EC Series Electrical System Mandatory Product Improvement

Trans/Air Manufacturing maintains a policy of continuous improvement of our products and services. In keeping with this philosophy, Trans/Air is issuing Mandatory Product Improvement 09-002, to address the following key areas of concerns in the aftermarket installation of Trans/Air EC series electrical Climate Control Systems.

Trans/Air has developed a product improvement kit p/n 5031234 for EC2.0 & EC2.5 and kit p/n 5031233 for EC3.0

Fig 1

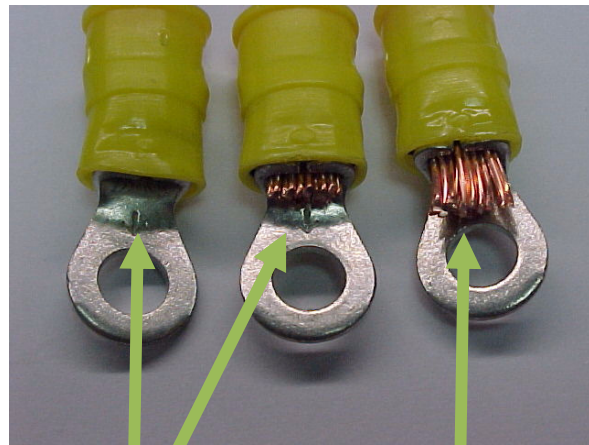
1. Crimps on the wires going to the terminal strip of the relay board should be uniform and tight. There should be no bare wire visible between the wire insulation and the terminal, and strands on the ring end should be cut flush or close to the terminal barrel, so there is no interference under the screw head. (Fig 1 & Fig 2)

Fig 4**Heat discoloration of a poor (loose) crimp**

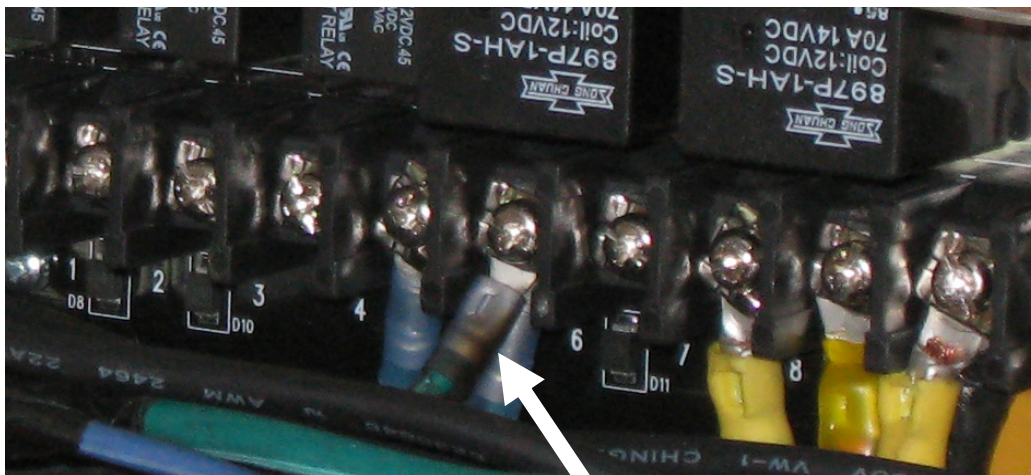
Conductive material on relay board. (Metal shaving etc.) Loose wire terminal screws at the relay board, or improper crimps
